South Penrith Network Investment

Case for Investment
Revision 1 (March 2022)

Version	Date	Comments
0	August 2020	Initial issue
1	March 2022	Addendum added to detail the additional scope for preferred option. Sections updated: Executive summary and Recommendation.

11. Addendum (Revision 1)

Figure 6 – Penrith TS 11kV transformer and BESS Proposed Operating Configuration

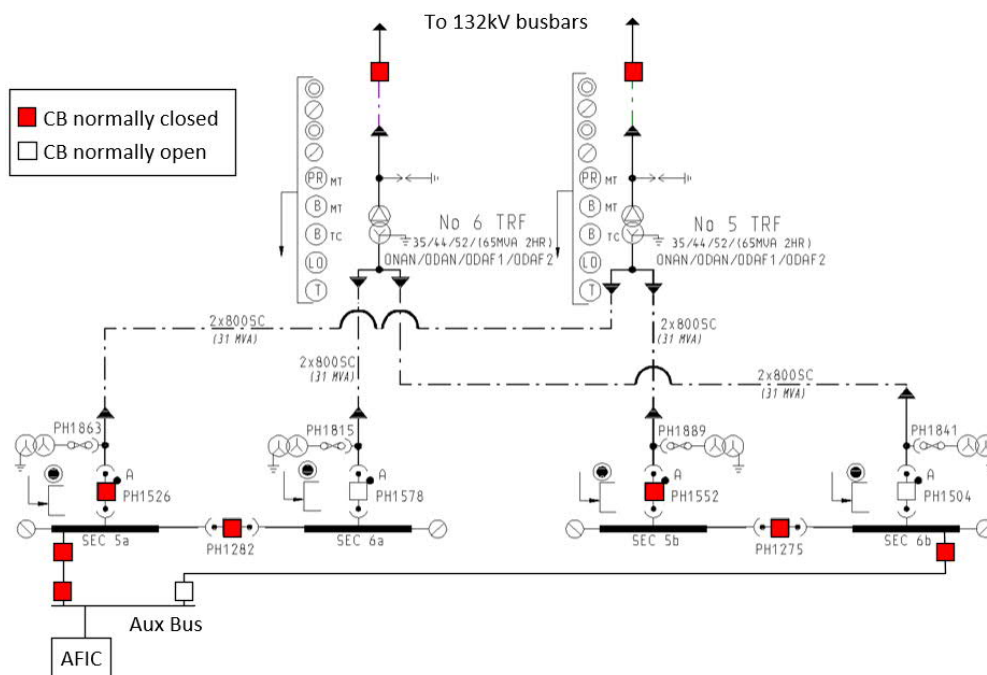
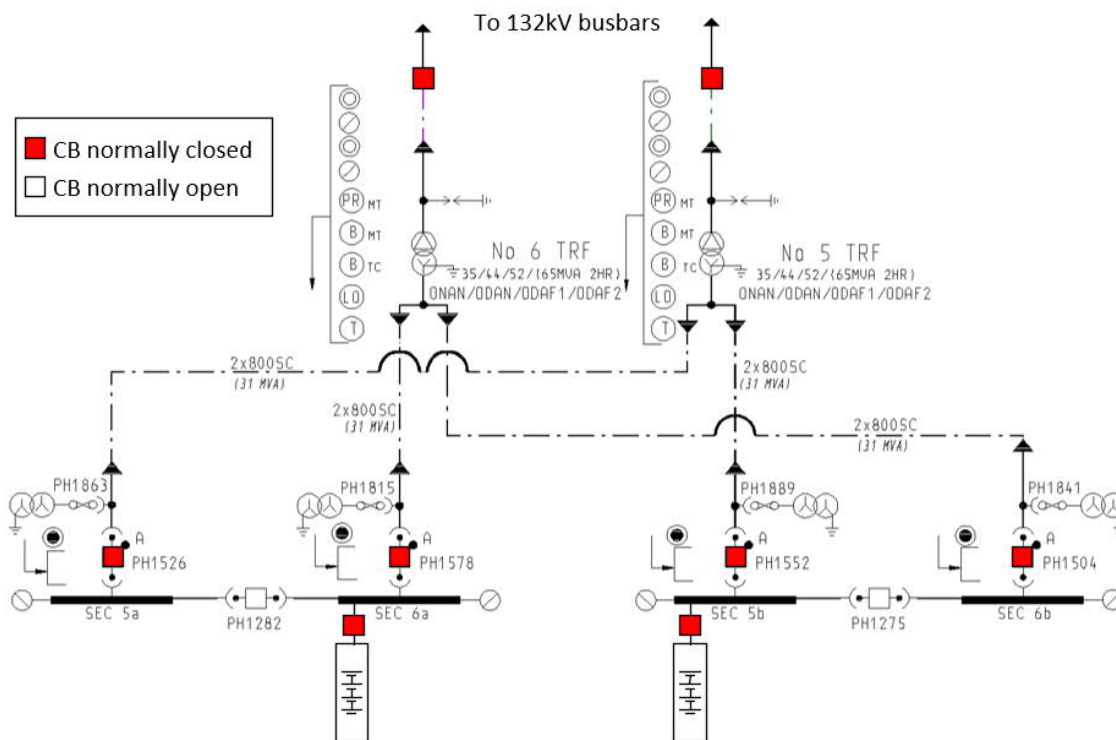
In reference to **Figure 5**, the Penrith 11kV network is currently operated with only one transformer in service. This is required to keep the network fault level below the ratings of primary network equipment. The two 52MVA transformers operate in a hot-standby configuration with an auto-standby routine providing restoration in the event of a transformer trip. The 11kV busbar is operated in a solid configuration and a single Audio Frequency Injection Cell (AFIC) provides controlled load facilities to all customers. In this configuration, Penrith 11kV is limited to 52MVA.

The connection of the BESS allows additional load to be supplied through the 11kV busbar and feeders while keeping power transformers below required ratings. To mitigate against the risk of cascaded trip events, and to be able to supply loads greater than firm transformer capacity, it is required that both transformers be normally on-line. However, to keep all primary equipment within their allowable fault levels the 11kV busbar will be operated in a split configuration (refer to **Figure 6**). In this configuration the existing Auxilliary Bus and AFIC configuration is no longer suitable as only half of the substation loads will have an AFIC signals available. The lack of suitable AFIC facilities must be addressed.

It is required that Endeavour Energy address the lack of insufficient AFIC facilities at Penrith 11kV following the installation of the BESS, and this should be done in the context of the incompatibility with the BESS. Additionally, secondary systems and distribution automation works required to be funded.

Zone:	Penrith, 9769	Item No:	MHN04914	Amd No:	0
Feeder:	PH1208/A – Castlereagh Rd	LG Area:	PENCC		
Location:	Castlereagh Road, Penrith	Prepared:	Gavin De Hosson

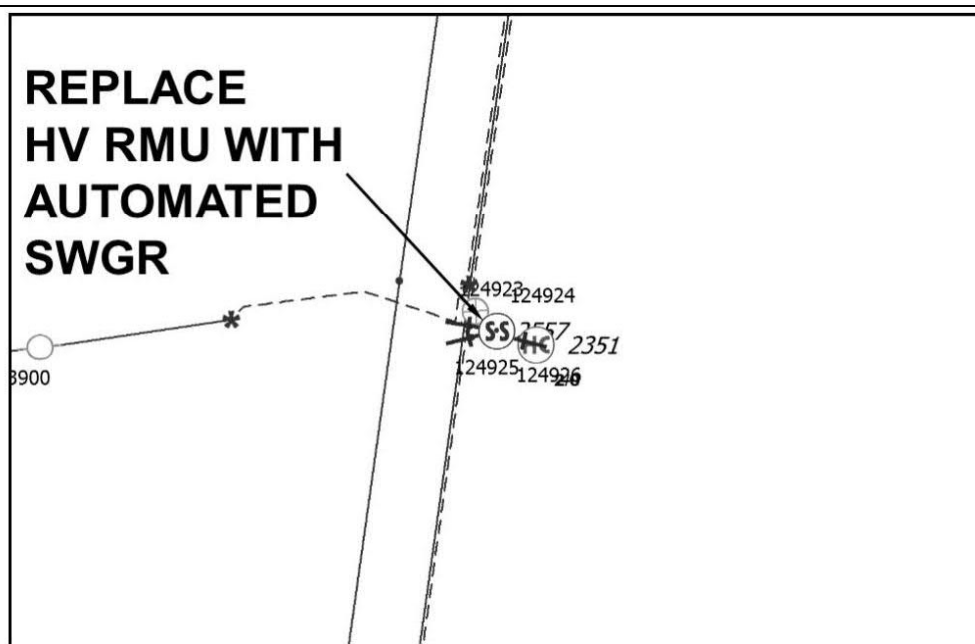
Connection headworks required for the grid battery.

Replace HV switchgear in Switching Station 2557 with automated switchgear.

Replace existing HV Sw/Gr in SS 2557 with automated four feeder unit.

Zone: **Penrith, 9769**Item No: **MHN04915** Amd No: **0**Feeder: **PH1208/B – Coreen Ave**LG Area: **PENCC**Location: **Castlereagh Road, Penrith**Prepared: **Gavin De Hosson****Reason for Works**

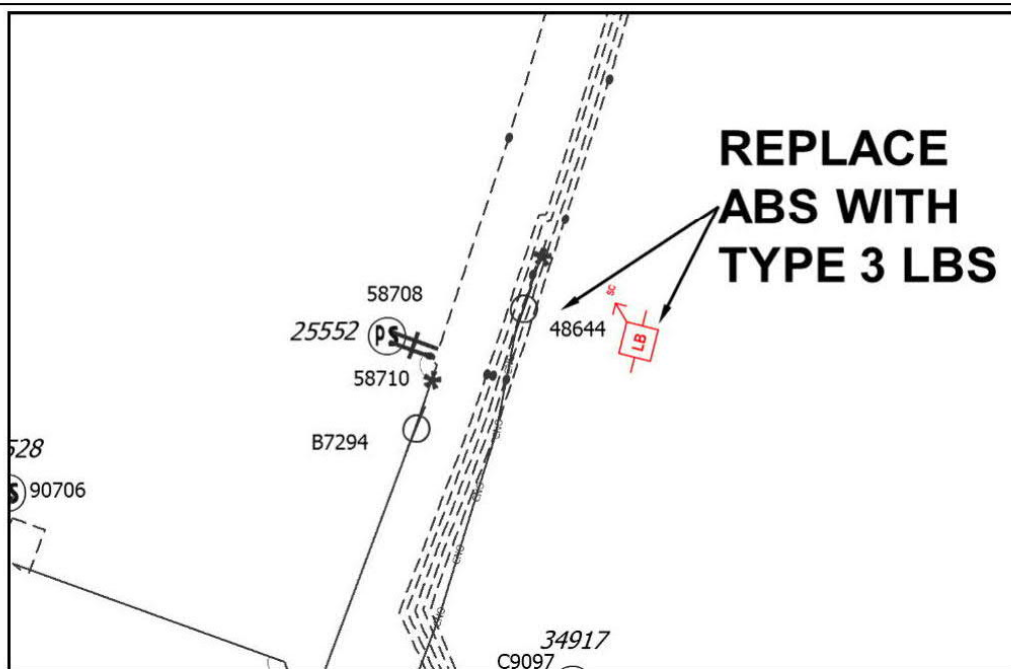
Connection headworks required for the grid battery.

Replace ABS 48644 with Automated LBS.

Remove existing ABS 48644.

Install a SCADA controlled LBS (Type 3) in place of the removed ABS as indicated.

Zone: **Penrith, 9769**
 Feeder: **PH1223/A – Ladbury Ave**
 Location: **High Street, Penrith**

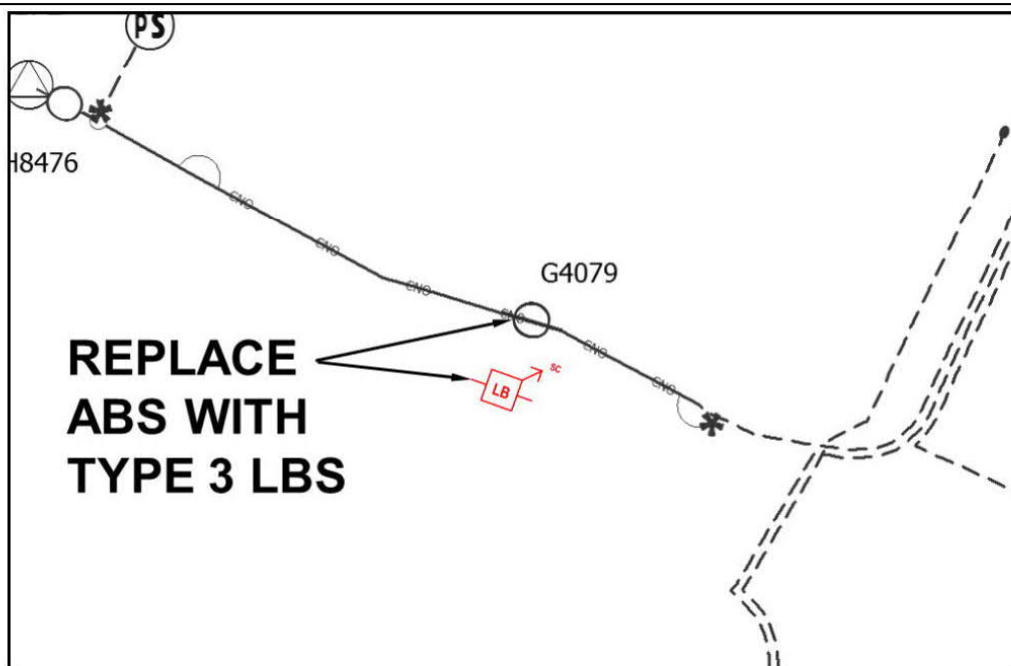
Connection headworks required for the grid battery.

Replace ABS G4079 with Automated LBS.

Remove existing ABS G4079.

Install a SCADA controlled LBS (Type 3) in place of the removed ABS as indicated.

Zone: **Penrith, 9769**Item No: **MHN04917** Amd No: **0**Feeder: **PH1223/B – Tax Office**LG Area: **PENCC**Location: **Combewood Avenue, Penrith**Prepared: **Gavin De Hosson****Reason for Works**

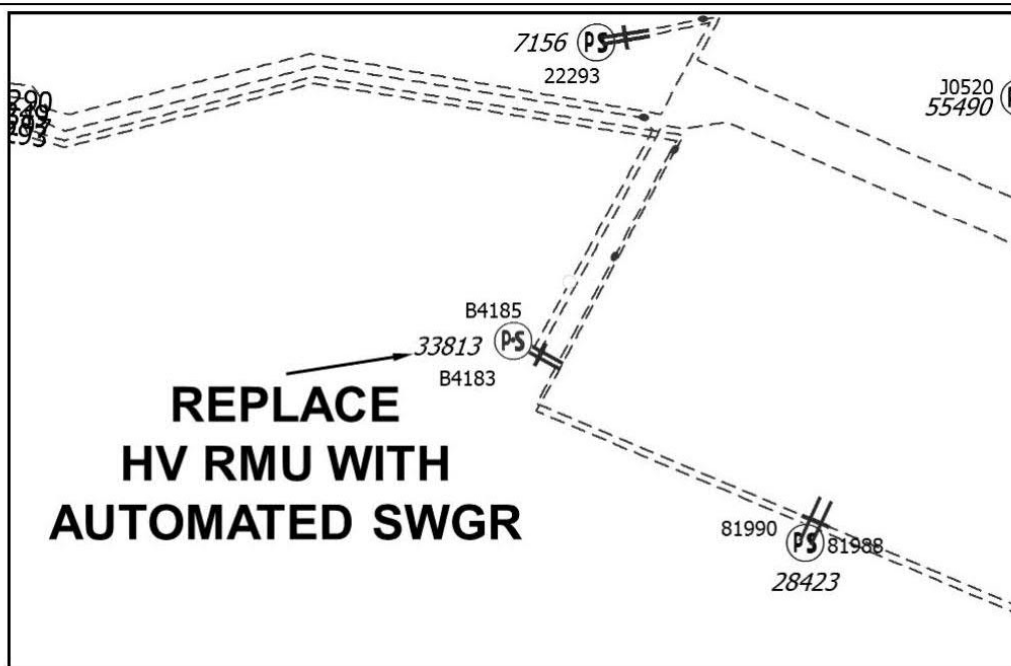
Conenction headworks required for the grid battery.

Replace HV Switchgear in DS 33813 with automated SWGR.

Replace existing HV Sw/Gr in sub 33813 with automated two feeder unit.

This is an existing 2 switch HV unit. Replace with another 2 switch unit, with only ONE switch automated.

The switch to be automated must be the switch on cable toward Penrith ZS (i.e. in the current position that switch B4185 is in).
